SUBJECT PROJECT CONCEPT REPORT APPROVAL

SUBJECT PROJECT CONCEPT REPORT

Project Concept Report

Concept Team Meeting Minutes
Project No. BRST-1308(11)
SR 81 Bridge over Alcovy River 2 miles SW of Bold Springs
P.I. No. 142295

STATE OF GEORGIA
 DEPARTMENT OF TRANSPORTATION
TYPICAL SECTION
 PROJECT - BRST-1308111
 COUNTY - WALTON
 DATE 02/25/02 SH 1 OF 2

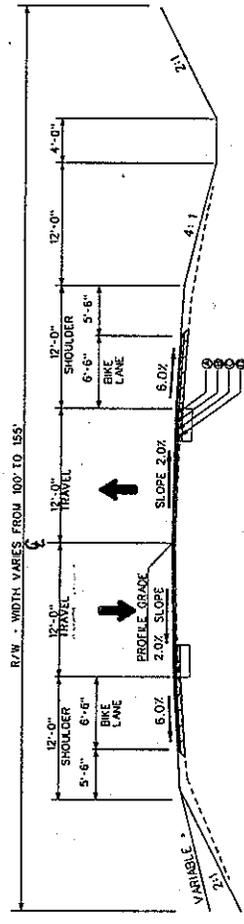
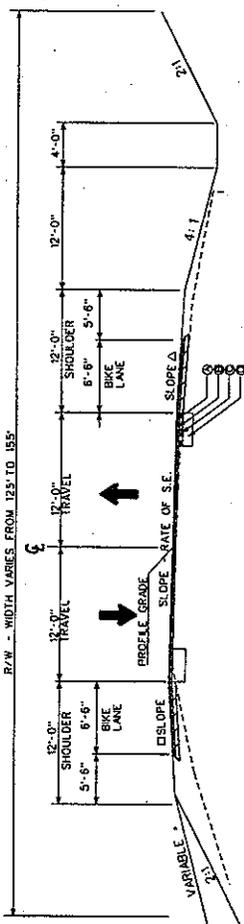
Design: Todd L. asked about speed design. Carol B. indicated that proposed 55 mph speed design would be met with 6 per cent maximum grades and 2 degree maximum degree of horizontal curvature. Ted C. questioned the requirement for bike lanes because the need and purpose statement indicated this was not a bike lane route. Todd L. checked the latest records and found this route is currently a designated bike lane route. There was general discussion on the use of rumble strips on the shoulder and on the bridge. Carol B. stated she would research the latest requirements and update the concept report. Neil K. stated that clear zone should be checked. Ted C. stated that the proposed full depth paving should extend to the face of the guardrail, then a thin layer of surface course to the shoulder break point for maintenance reasons. All agreed with the proposed dimensions and slope controls of the typical sections.
